LICENSE NUMBER: 24-16273-01

LICENSEE: Sigma-Aldrich Company

SUBJECT: NRC SAFETY EVALUATION REPORT OF REVISED  
DECOMMISSIONING PLAN AND LICENSE TERMINATION REQUEST  
FOR THE SIGMA-ALDRICH FORT MIMS SITE

Figure 1. Carbon-14 soil concentrations from 0-15cm depth (adapted from ADAMS Accession No. ML17240A366)

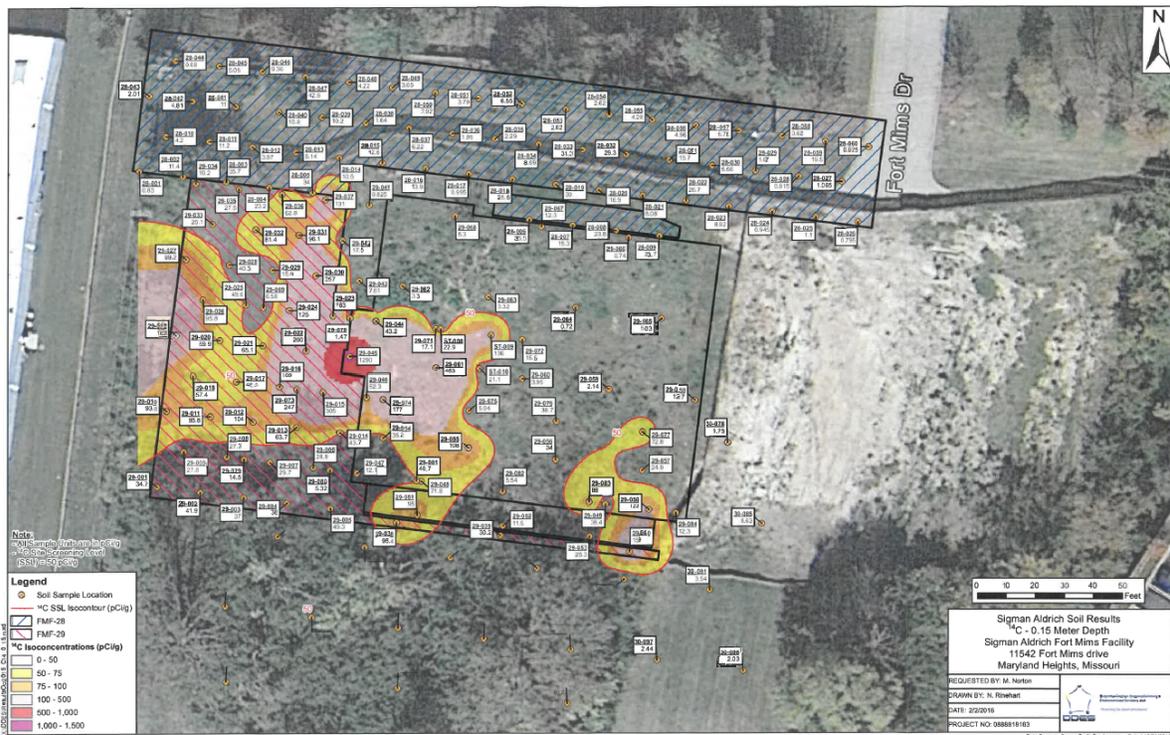
The groundwater at the Fort Mims Site is shallow (e.g., approximately 4.6-6.1 m [15-20 ft] below ground surface) and the permeability of the soils is low because of the fine-grained sediment (e.g., silty clay and clayey silt). In addition, contamination at the site decreases with depth as shown in Figure 1 through Figure 4. Accordingly, most of the contamination appears to be in the top 1 m (3.3 ft) of soil. However, contamination that may have migrated below the sampling depth would likely be observed in the groundwater monitoring wells shown in Figure 5. These wells are located beneath and down gradient from the Fort Mims Site.

Figure 5. Groundwater Monitoring Well Locations and Water Table Elevation (adapted from ADAMS Accession No. ML17240A366)

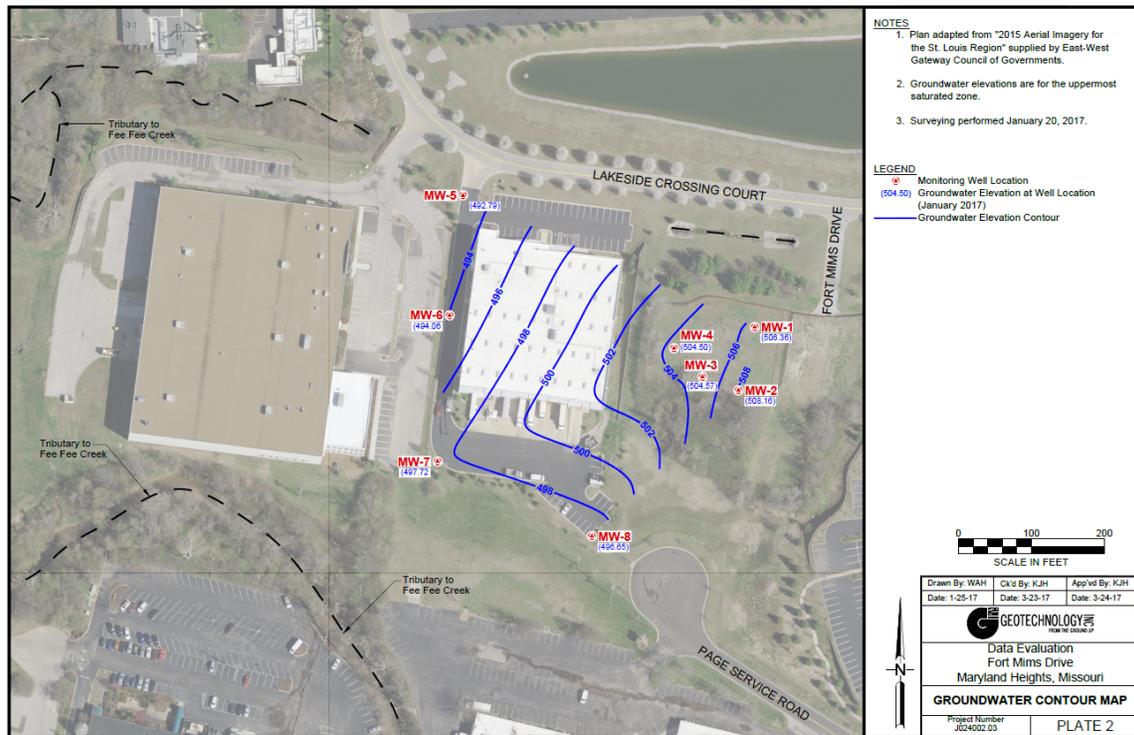
By letter dated May 2, 2018 (ADAMS Accession No. ML18155A219), Sigma provided updated groundwater monitoring results from eight monitoring wells at the Fort Mims Site, as shown in Figure 5 below. Both C-14 and H-3 were detected in the groundwater with maximum observed concentrations of 647 pCi/L for C-14 and 13,500 pCi/L for H-3. Contaminant concentrations at these wells have remained relatively steady since the well monitoring began in May of 2016.

NRC staff, in coordination with the Oak Ridge Institute for Science and Education, conducted confirmatory groundwater sampling for C-14 and H-3 (ADAMS Accession No. ML16195A308, ML16195A309). Those sampling results were consistent with Sigma's results, which are documented in their revised decommissioning plan (ADAMS Accession No. ML19273A160). NRC staff also conducted an independent analysis of the dose due to ingestion of the groundwater. Based on the groundwater ingestion dose conversion factor in RESRAD, assumed ingestion of 1.4 L/day of water, and the maximum observed concentrations of C-14 and H-3 of 647 pCi/L and 15,003 pCi/L, respectively, the total potential dose from groundwater ingestion would be approximately 1.9 mrem/yr.
